MEMORANDUM

REVIEW TYPE: **Project Plan Review**

CASE #: **920060050**

PROJECT NAME: **The Rugby Condominium**

Proposed 101 Foot Building – Front Facade

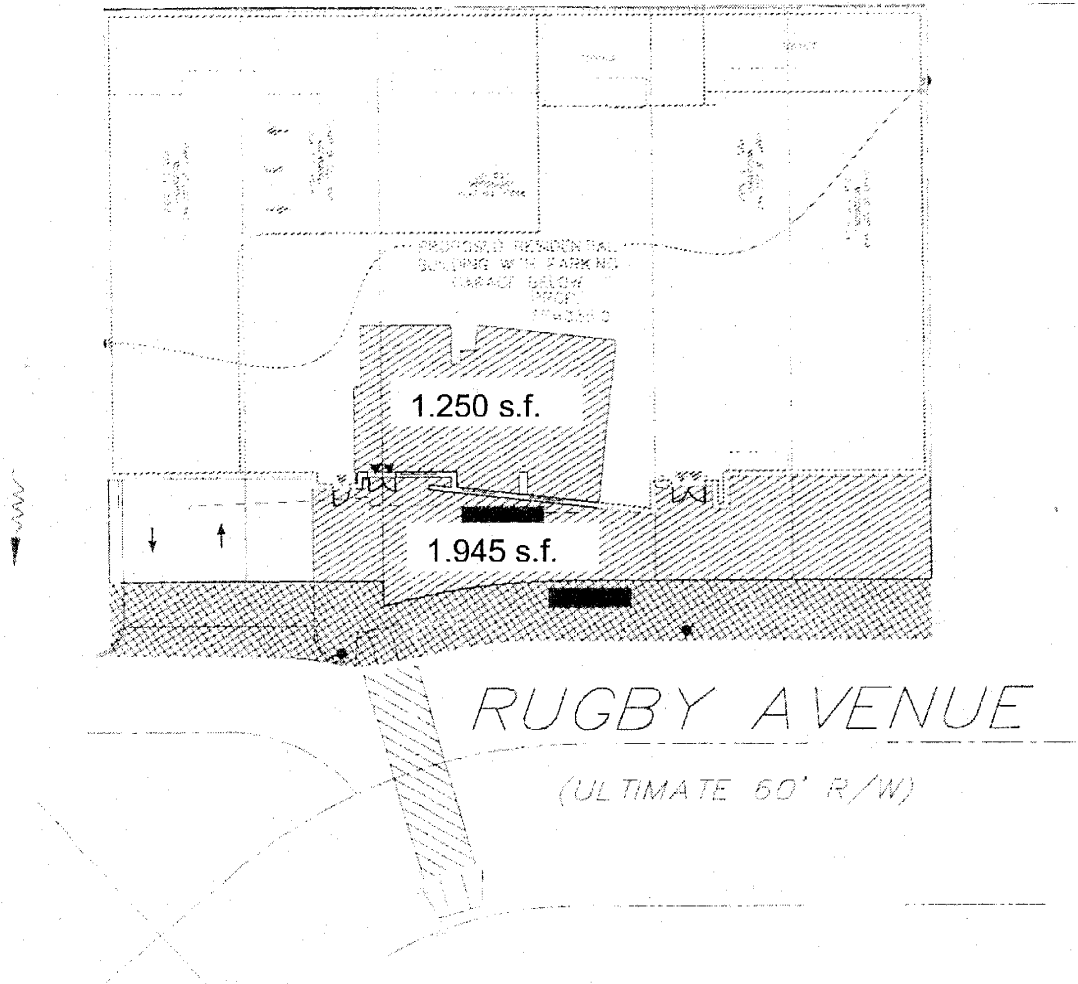
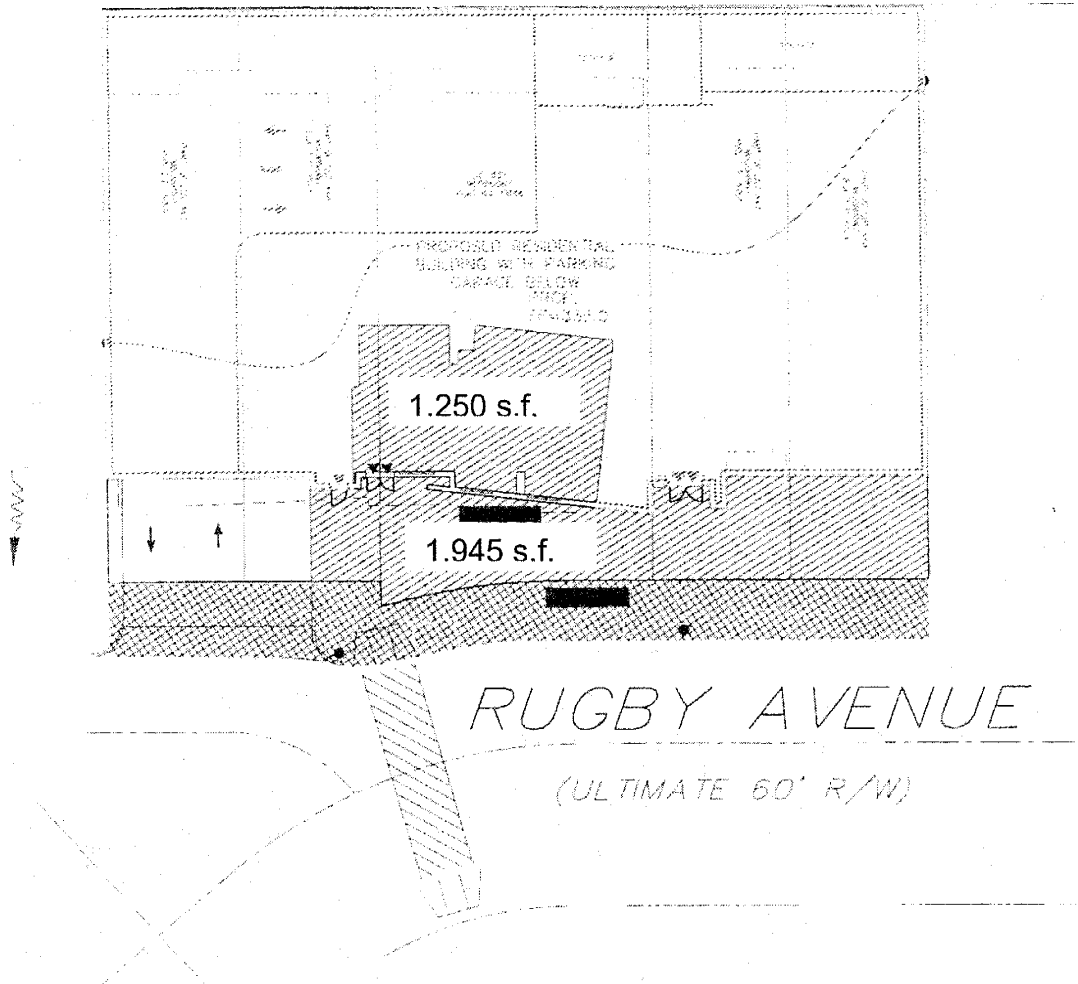
The Applicant, 4851 Rugby Avenue, LLC, proposes a 10-story, 101-foot condominium building with 15% percent MPDU's built on site. The maximum height allowed in the zone is 90 feet for the proposed project. Staff would recommend approval of the project at 90 feet including, at a minimum, the currently proposed amenity component. The applicant previously agreed to provide approximately 1,250 square foot of artist studio work and exhibit space on the first floor with a separate entrance onto the front plaza. The art studio space would be open to the public on a scheduled basis. The frontage of the site would be developed with a small green space and a gathering area near the arts space. The applicant would also provide a facility plan for Battery Lane Urban Park.

The project does not conform to the Woodmont Triangle Amendment because it exceeds 90 feet and is not a mixed-use project. While it would add to the supply of affordable housing in the area, it exceeds the maximum height allowed in the zone.
